Wisconsin Department of Transportation

Proposal #08: 5849-02-02, WISC 2020 038
C Fitchburg, McKee Road
Commerce Park Dr to Seminole
Hwy
CTH PD
Dane County

This is Addendum No. 01, which provides for the following:

ADDENDUM NO. 01
5849-02-02/5849-02-03
February 6, 2020

Addendum No. 01
ID 5849-02-02
Revised Sheet 2
February 6, 2020

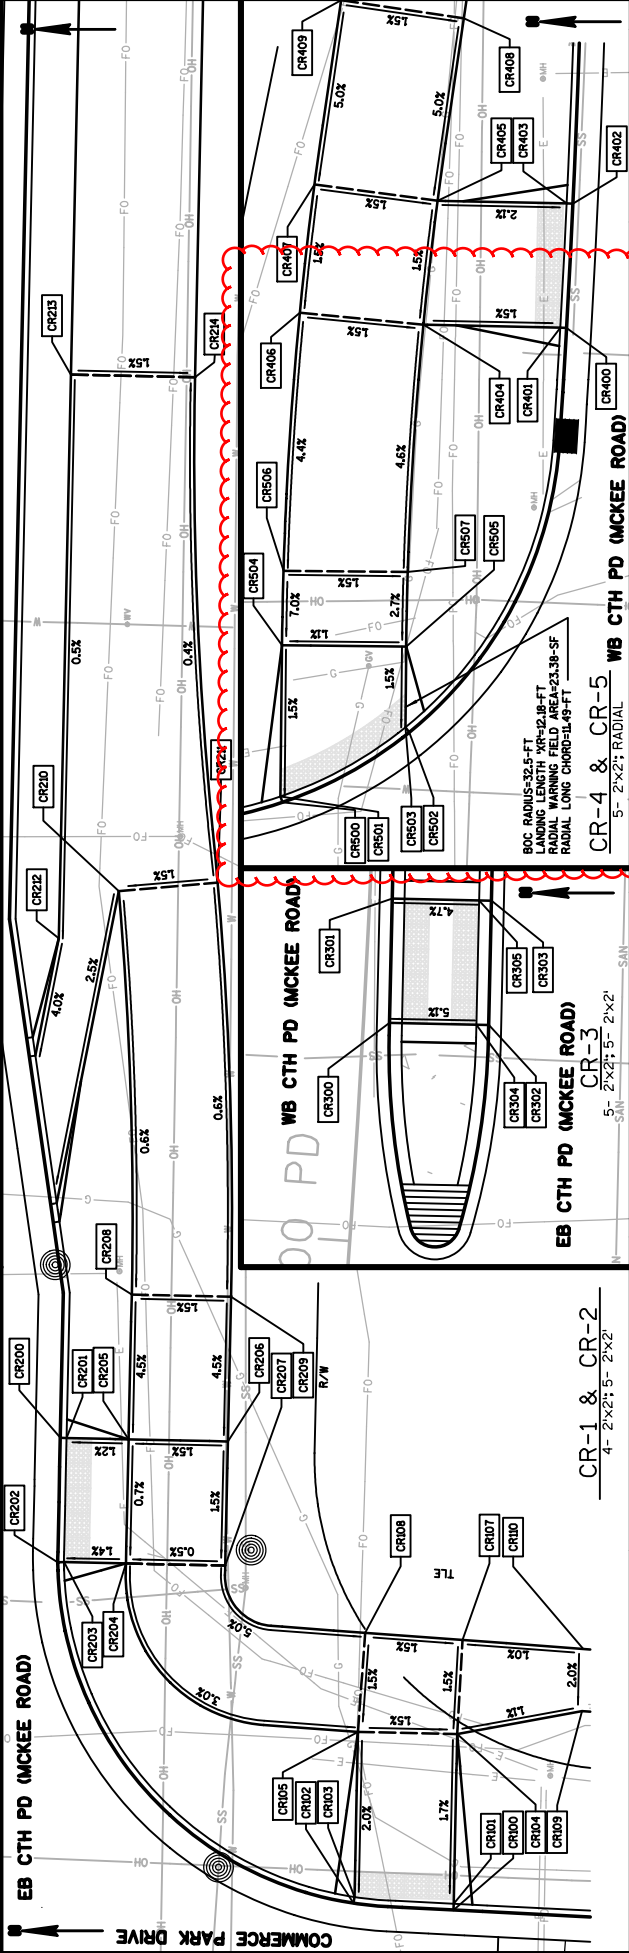
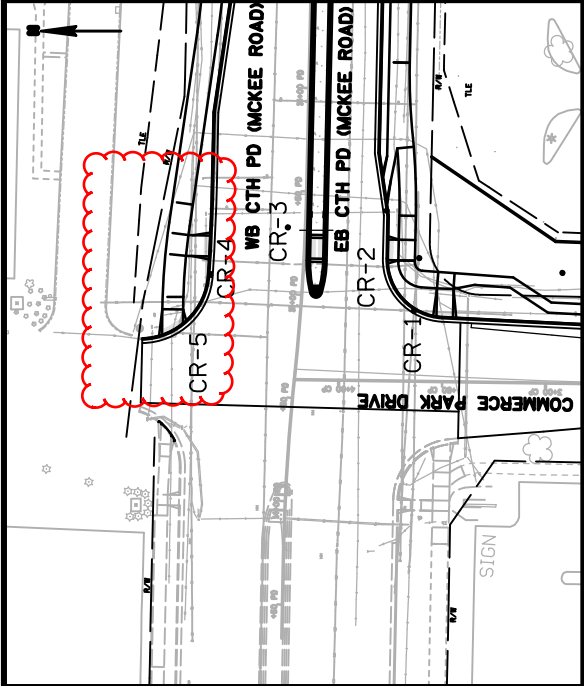
Revised Plan Sheets	
Plan Sheet	Plan Sheet Title (brief description of changes to sheet)
2	Revised the Charter Communication contact information.
32	Revised multiuse path and curb ramp layout.

Addendum No. 01
 ID 5849-02-02
 Revised Sheet 55
 February 6, 2020

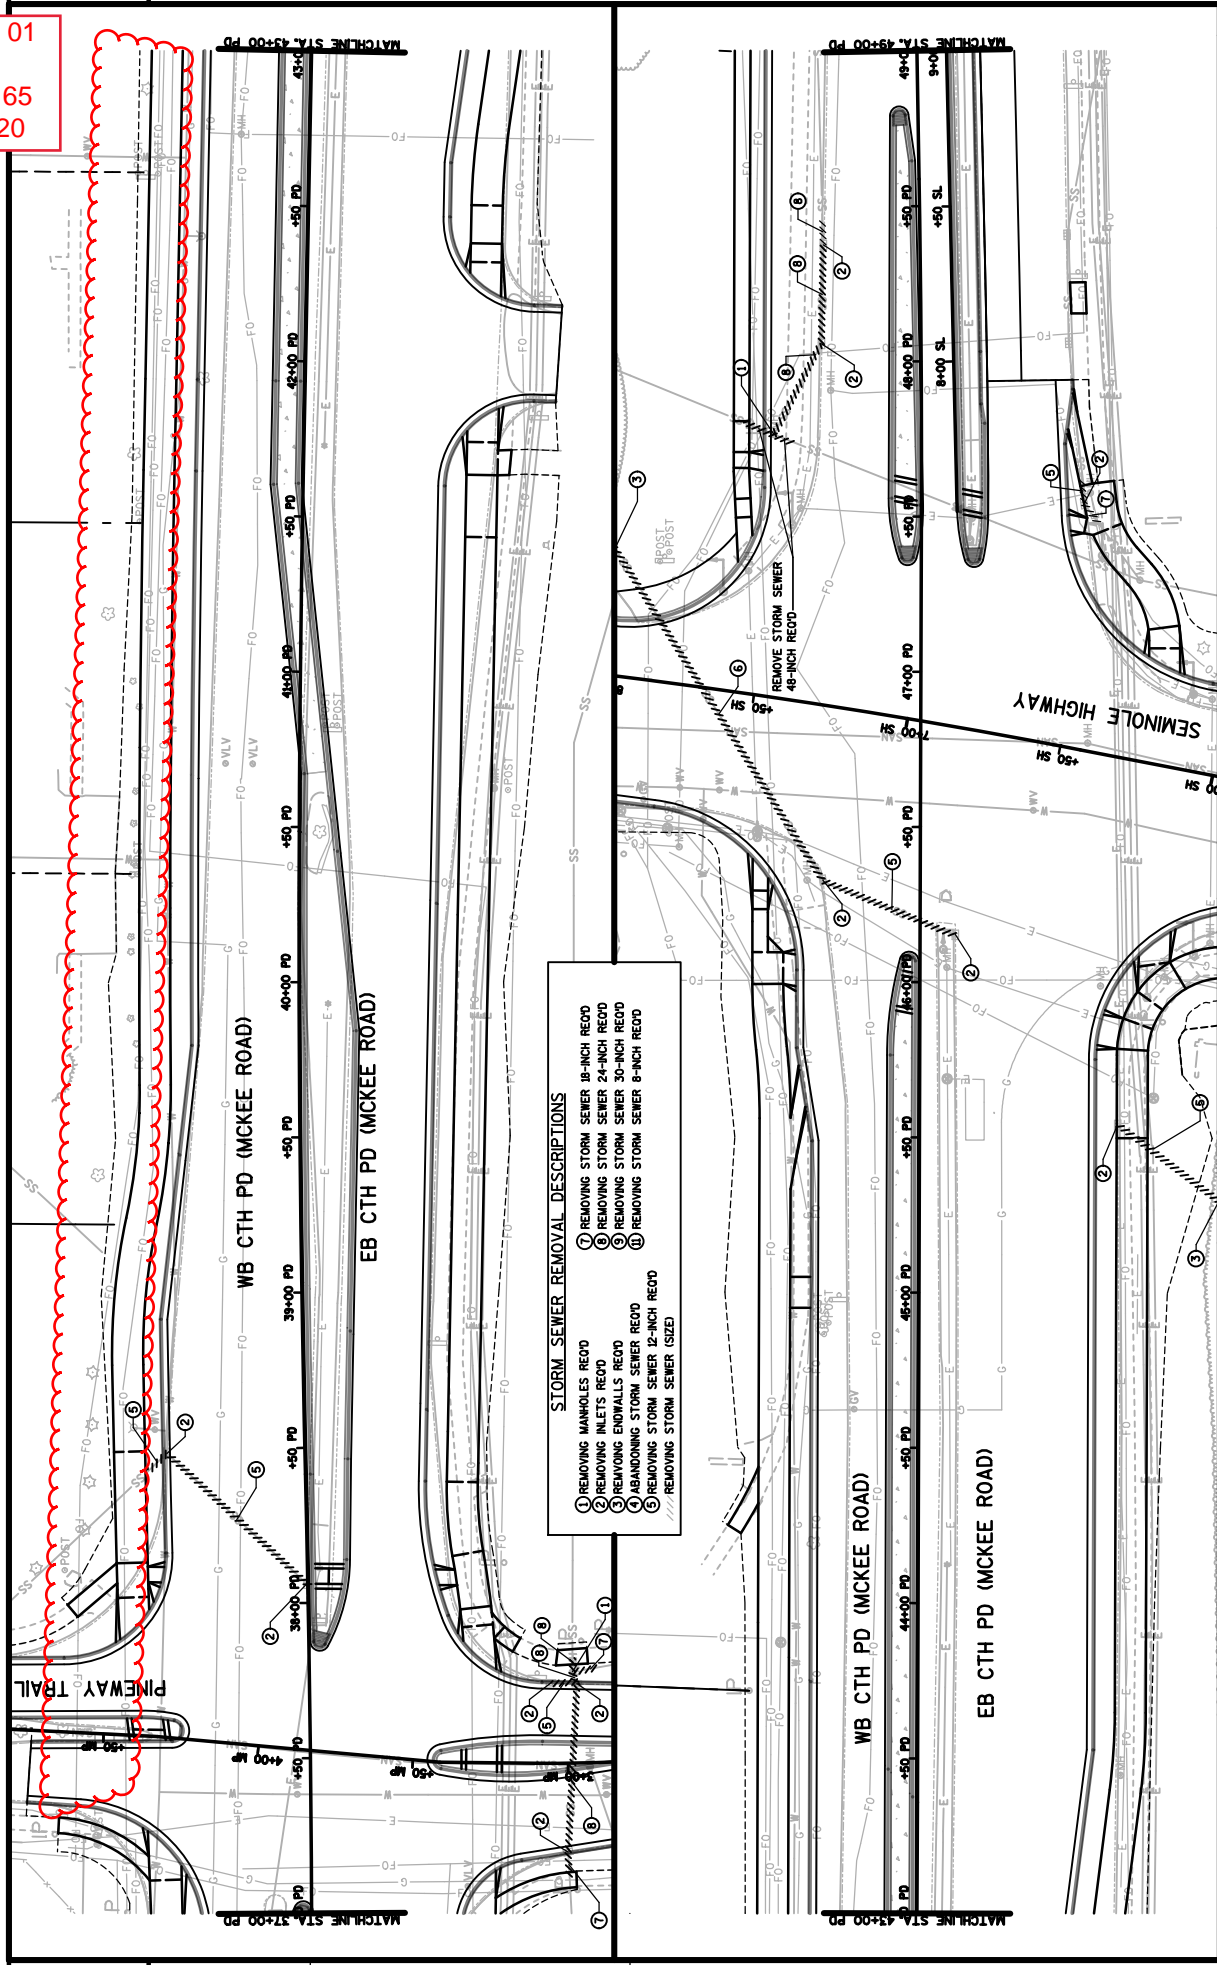
40	Revised multiuse path and curb ramp layout.
41	Revised multiuse path and curb ramp layout.
55	Revised multiuse path and curb ramp layout.
63	Revised multiuse path and curb ramp layout.
65	Added linework for Charter Communications underground facility.
68	Revised multiuse path and curb ramp layout and storm sewer rim callouts.
69	Revised to remove inlet sump and storm sewer rim callouts.
70	Removed inlet sumps and revised storm sewer layout and storm sewer rim callouts.
71	Removed inlet sumps and revised storm sewer layout and storm sewer rim callouts.
72	Revised storm sewer rim callouts and added linework for Charter Communications underground facility.
73	Revised storm sewer rim callouts and added linework for Charter Communications underground facility.
74	Revised storm sewer rim callouts.
75	Revised storm sewer rim callouts.
76	Revised storm sewer layout.
77	Revised storm sewer rim callouts.
78	Revised storm sewer rim callouts.

Addendum No. 01
 ID 5849-02-02
 Revised Sheet 81
 February 6, 2020

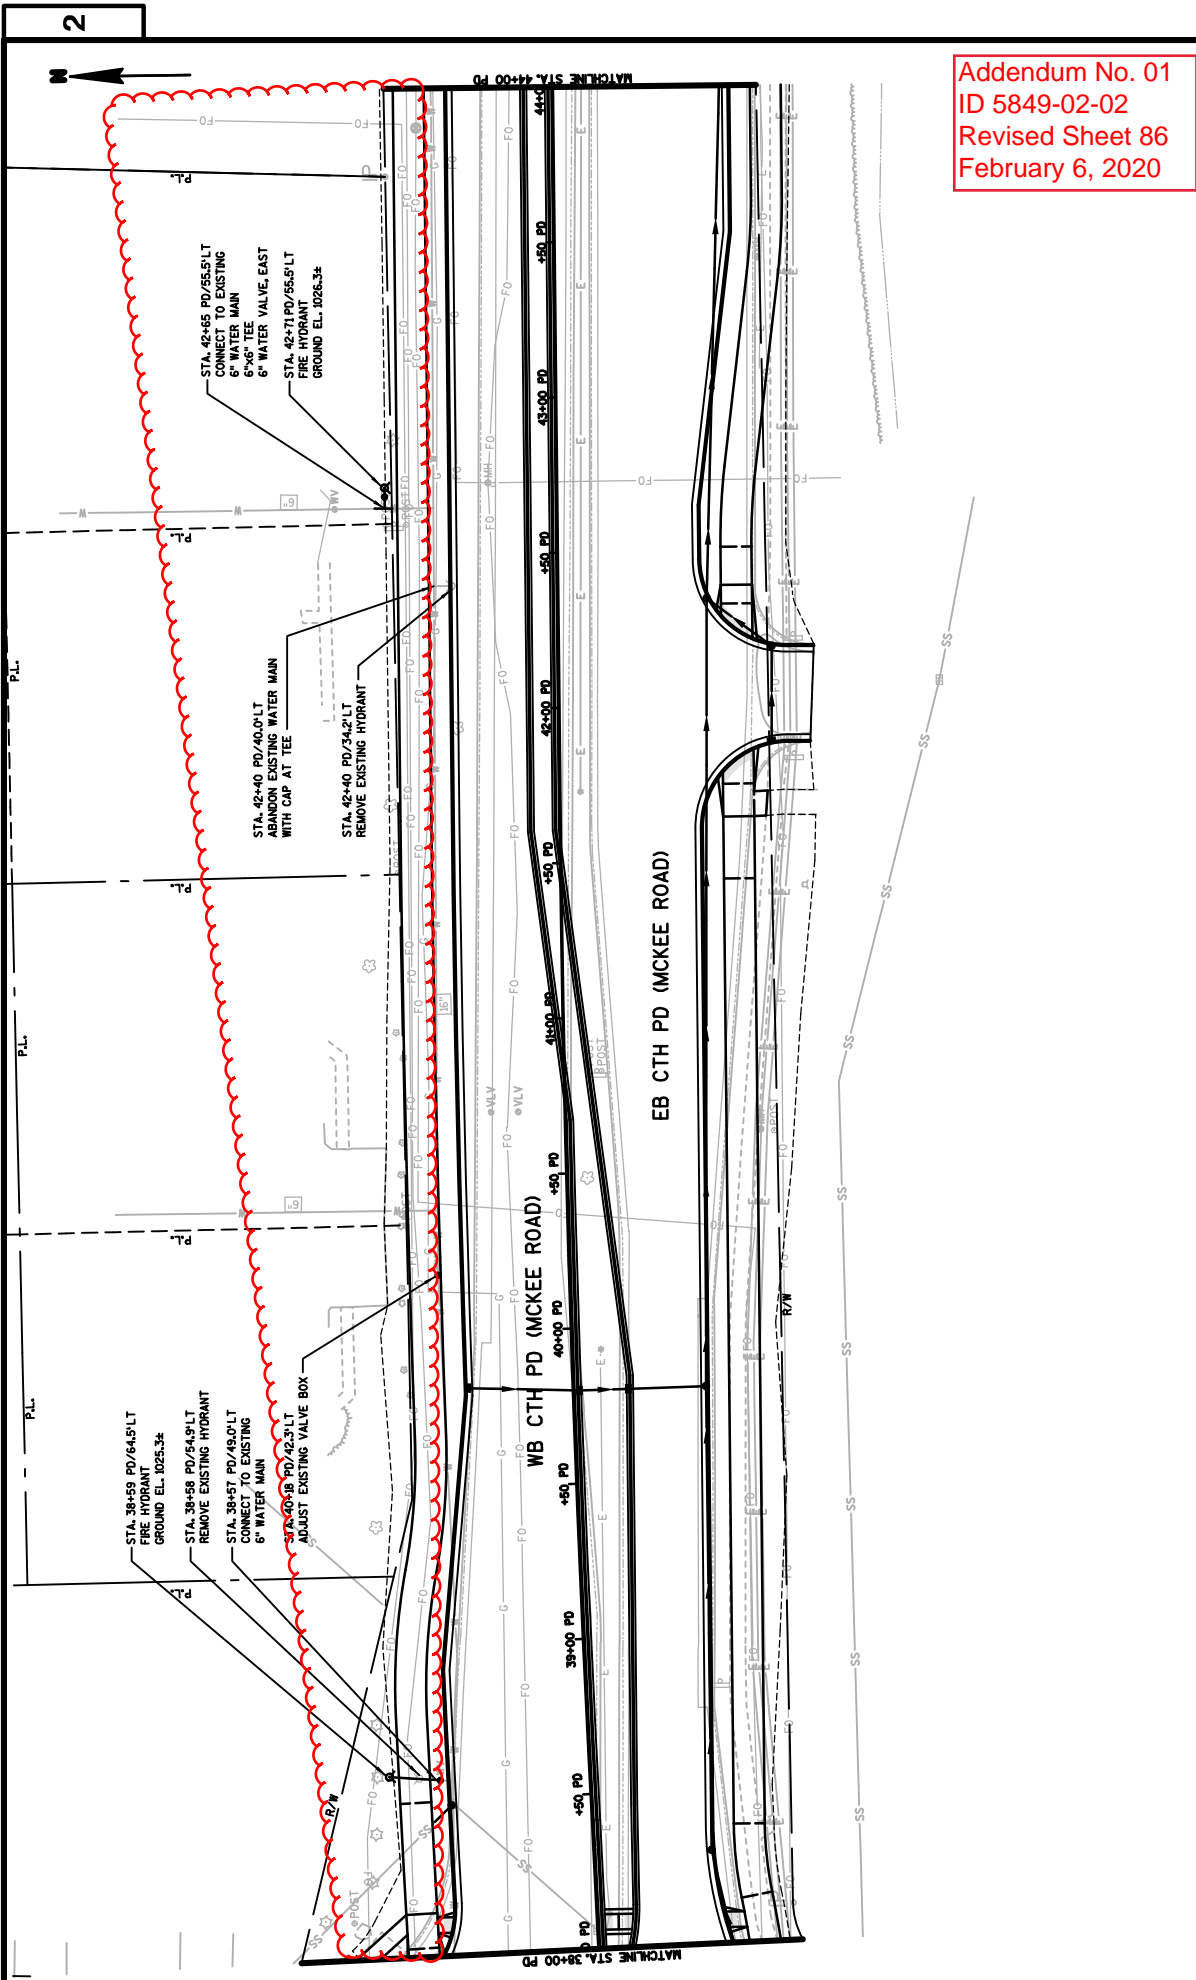
79	Removed inlet sumps and revised storm sewer layout.
80	Removed inlet sumps and revised storm sewer layout.
81	Removed inlet sumps and revised storm sewer layout.
82	Revised multiuse path and curb ramp layout.
86	Added linework for Charter Communications underground facility.
96	Revised multiuse path and curb ramp layout.
101	Added sign size.
104	Revised multiuse path and curb ramp layout.
130	Revised multiuse path and curb ramp layout.
138	Added linework for Charter Communications underground facility.
200	Revised multiuse path and curb ramp layout.
208	Revised multiuse path and curb ramp layout.
230	Added HMA Cold Weather Paving quantity.
232	Updated storm sewer quantities.
233	Updated storm sewer quantities.
235	Updated storm sewer quantities.
236	Updated Mobilizations Erosion Control quantities.
239	Updated sign quantity.
242	Added Cold Weather Marking items.
247	Revised signal pole location.
254	Revised Traffic Control items to accommodate extended completion date.

Addendum No. 01
 ID 5849-02-02
 Revised Sheet 267
 February 6, 2020

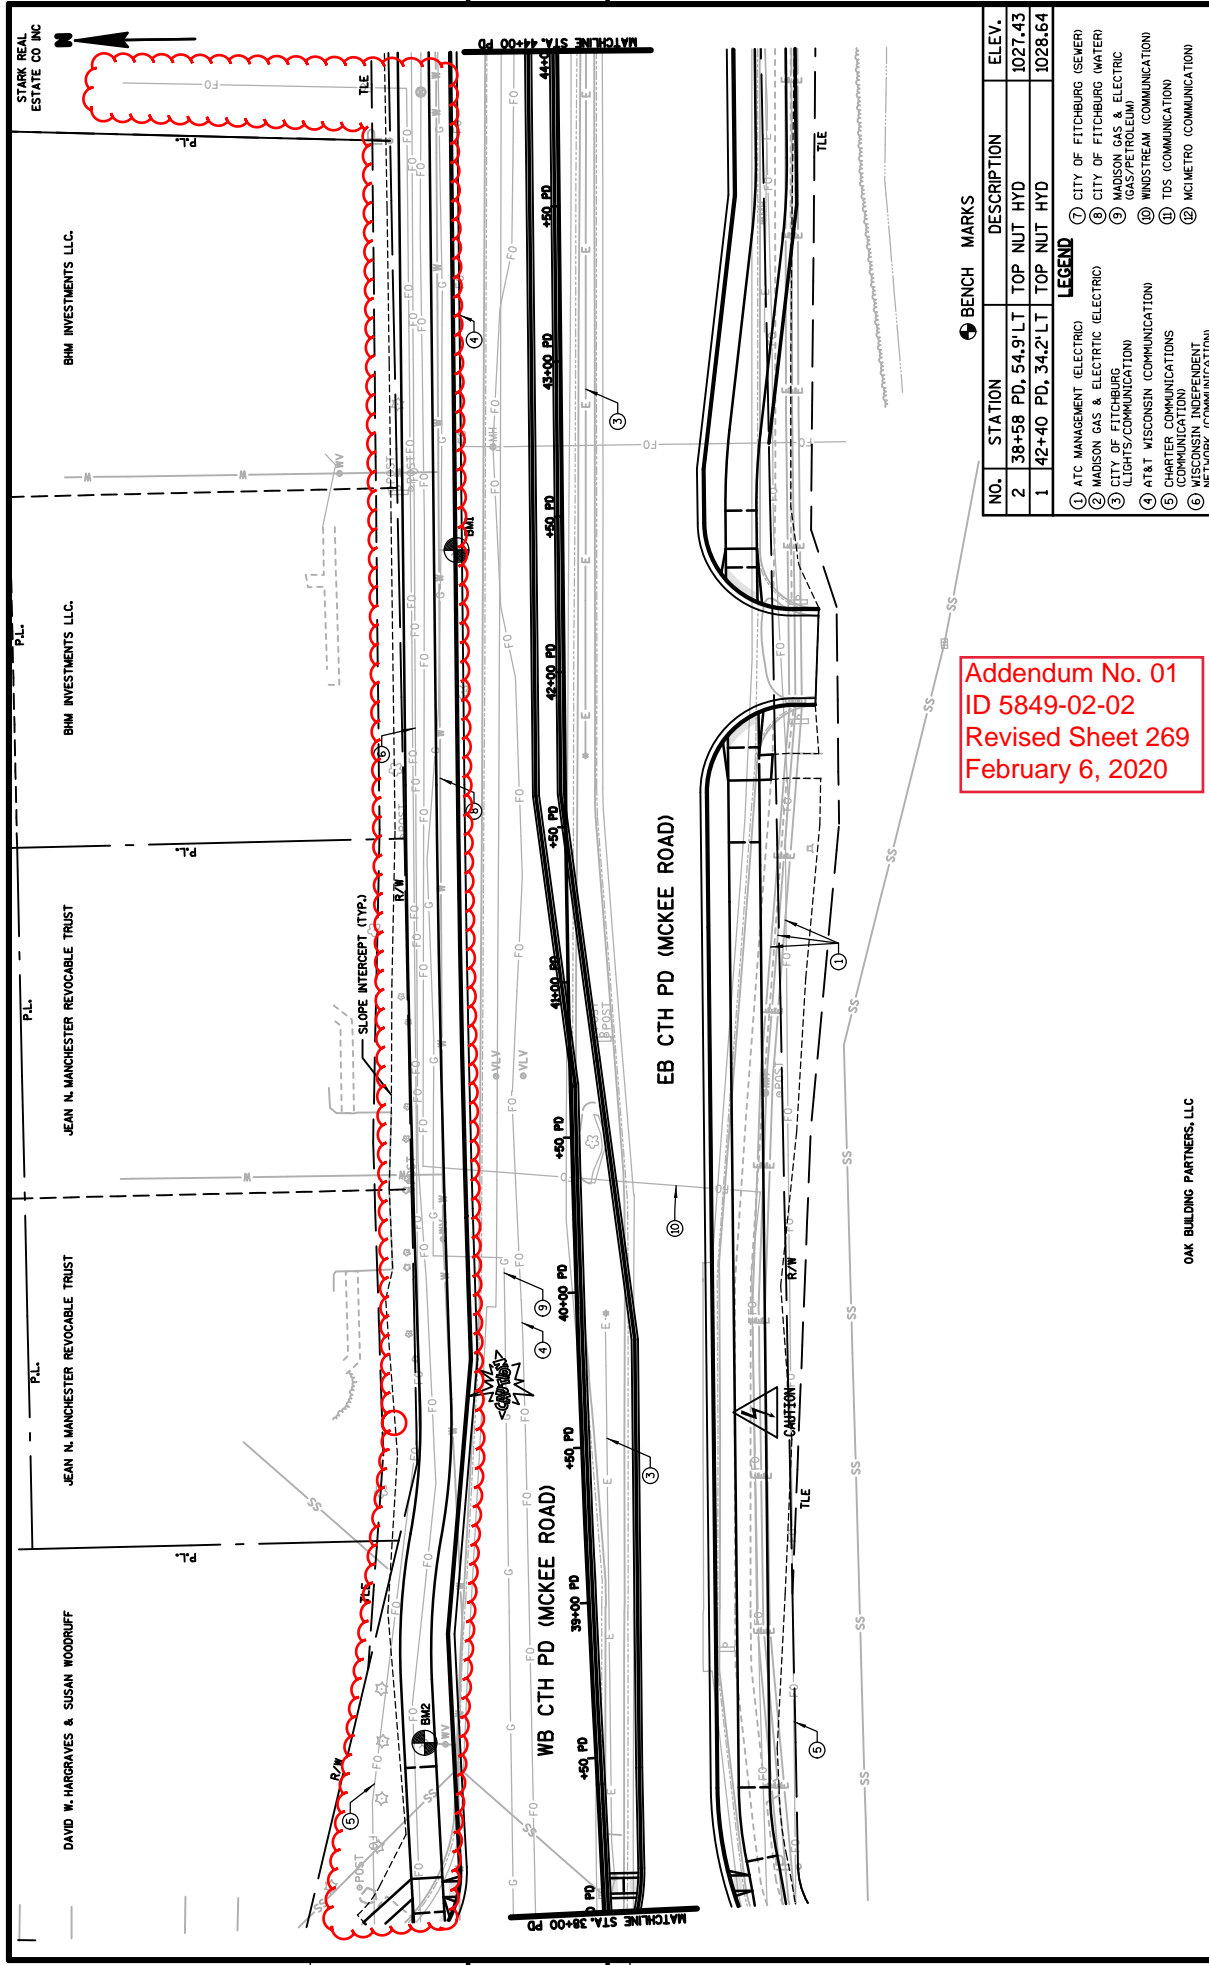
261	Revised multiuse path and curb ramp layout.
267	Added linework for Charter Communications underground facility.
269	Added linework for Charter Communications underground facility.
379	Added sign plate detail.
